CBD NORTH PRECINCT DEVELOPMENT PLAN

TAS-CYP-CBN-ZWD-PLA-XLP-TNC-X0001

REV J AMENDMENT – MINISTERIAL SUBMISSION

CHANGE REGISTER

Figure 1: Development Plan consultation process (blue refers to Early Engagement, orange refers to Public Display Period, and green refers to Stakeholder Engagement during detailed design)

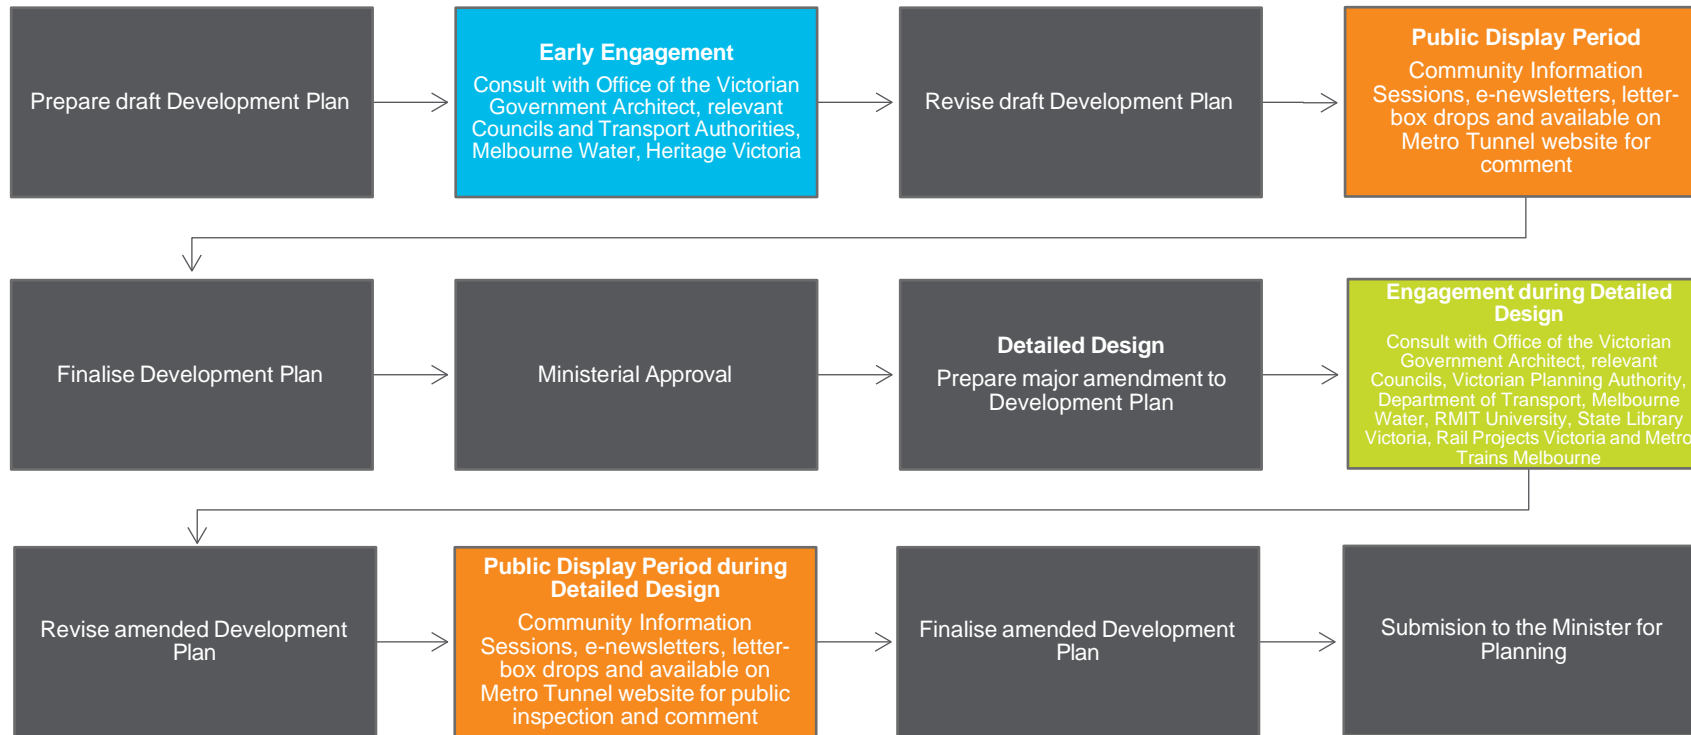
1.3.2 Stakeholder engagement during detailed design	New section added to outline stakeholder engagement post-Ministerial Approval of this CBD North Precinct Development Plan, and during detailed design
Figure 1	Updated to include the additional consultation process post-Ministerial Approval of this CBD North Precinct Development Plan
Figure 3	Figure updated to reflect the revised design

Figure 4: CBD North precinct components and station entries

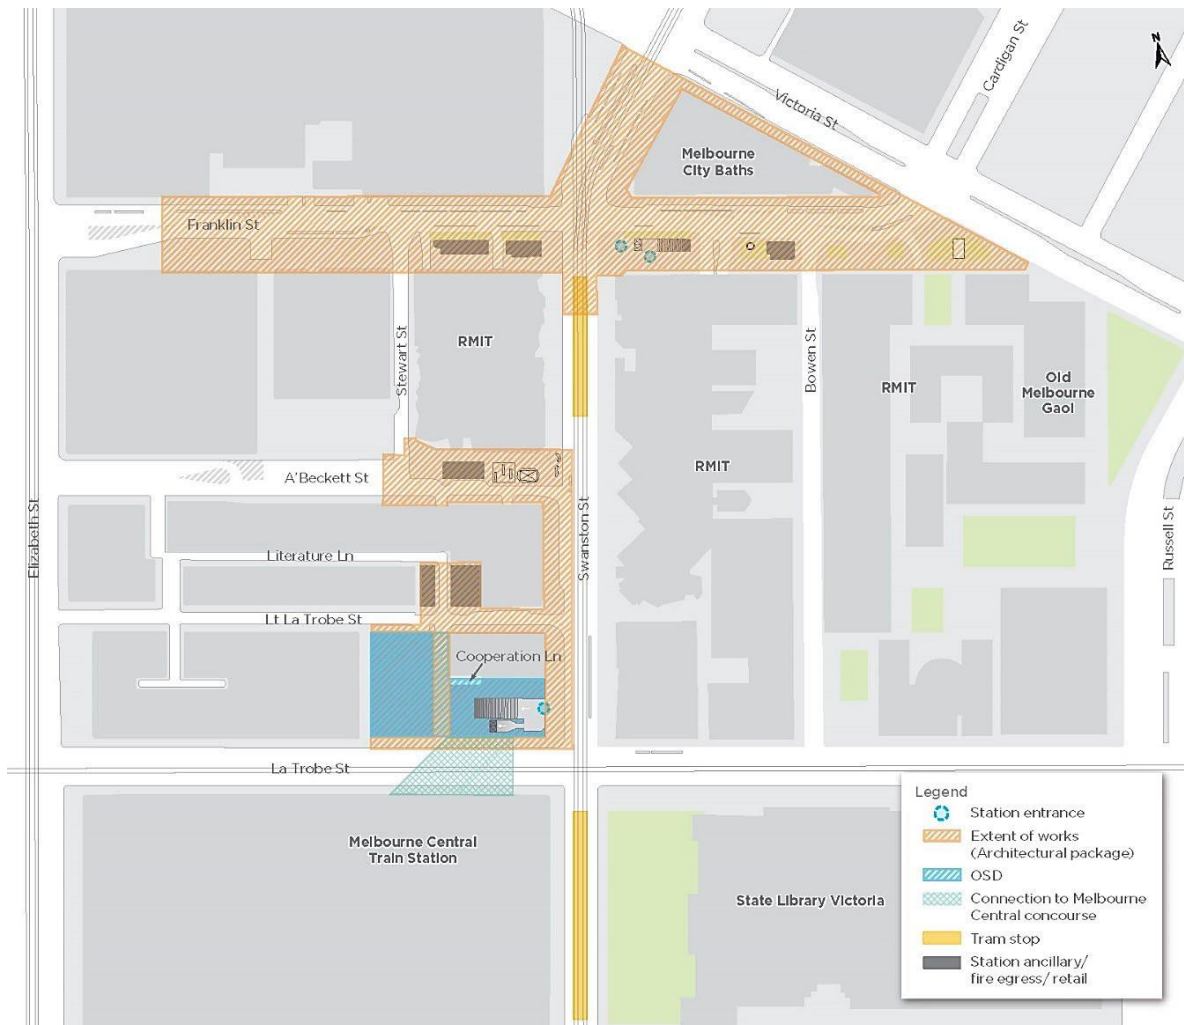
Changes can be found in Appendix B: Architectural Plans, Appendix C: Landscape Plans and Elevations and Appendix D: Public Realm Plans.
Figure 4	Updated to reflect the revised design

Figure 5: Indicative architectural illustration – East West cross section – Franklin Street

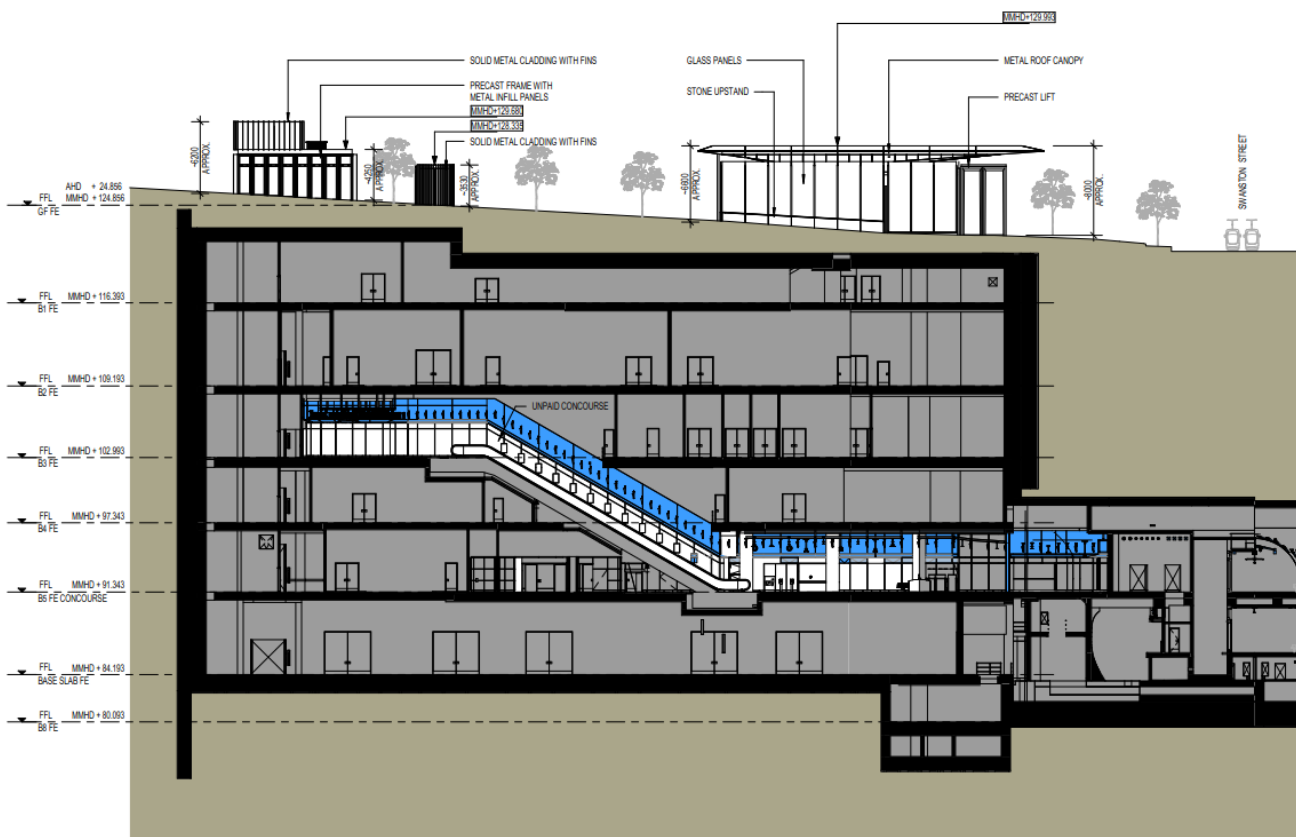
Figure 5	Updated to reflect the revised design
4.3.2 Landscape response	<p>Updated to reflect changes to the tree retention, removal and planting as part of the design development, including:</p> <ul style="list-style-type: none"> • Reduced effective footpath width (2.5m) at Franklin Street northern footpath to accommodate reinstatement of trees • Retention of existing trees on Swanston Street • Water sensitive urban design principles and its integration into the CBD North precinct • Increased and simplified garden beds facing onto Franklin Street. <p>Changes can be found in Appendix C: Landscape Plans and Elevations.</p>

Figure 10: Bicycle facilities at CBD North precinct

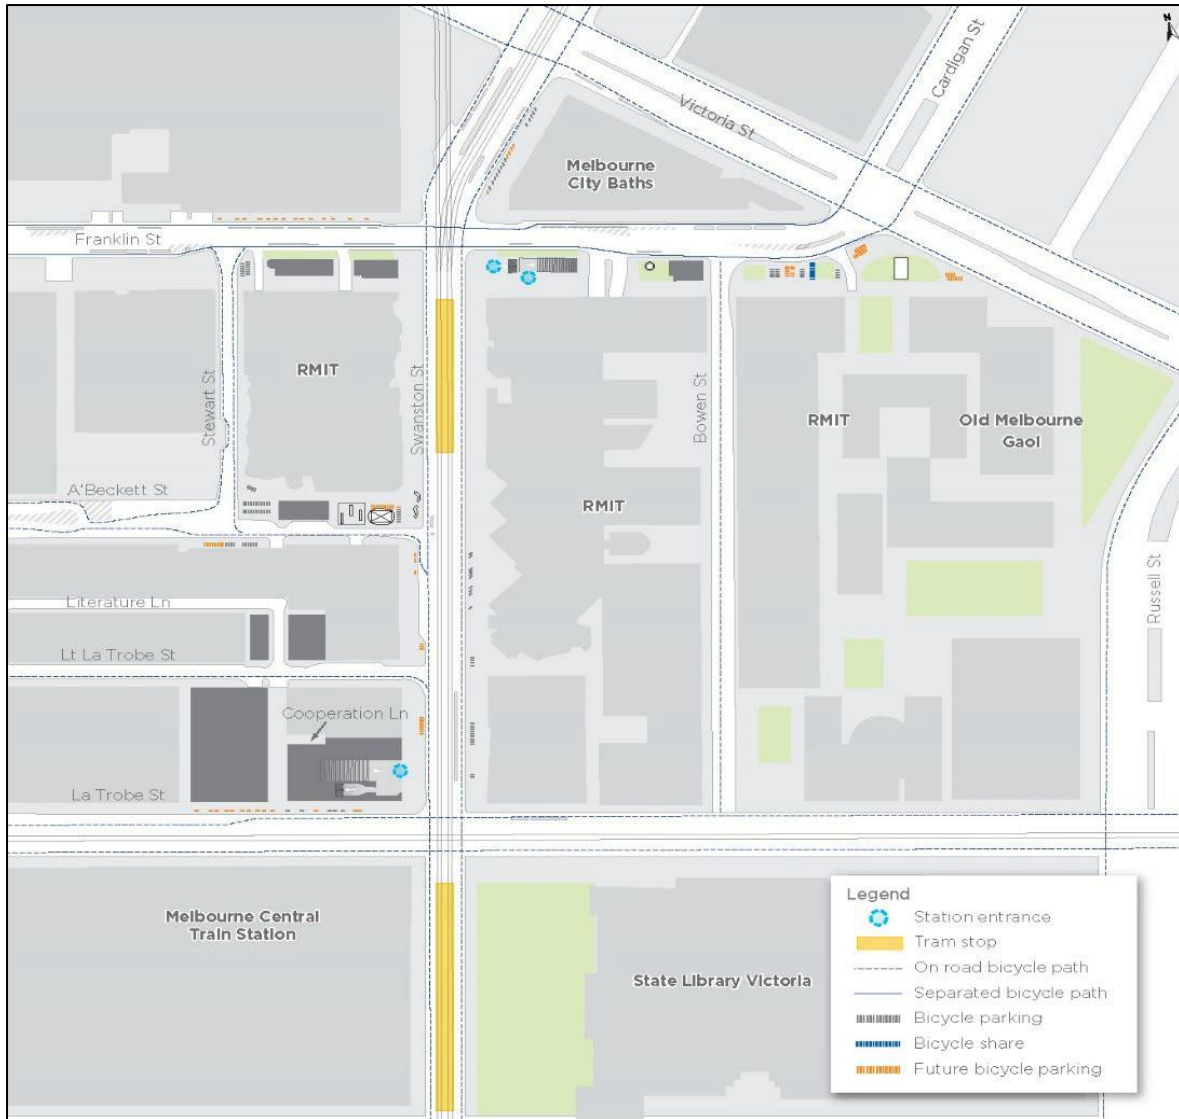
4.3.4.4 Transport integration	<p>Updated to provide detail on changes to parking and relocation of the Rail Replacement Bus Bay from Franklin Street to Victoria Street.</p> <p>Changes can be found in Appendix D: Public Realm Plans, including Hardscape Plan TAS-CYP-CN-00-DRG-AUD-CBN-732103-DP.</p>
Figure 8	Updated to reflect the revised design
Figure 9	Updated to reflect the revised design
Figure 10	Updated to reflect the revised design
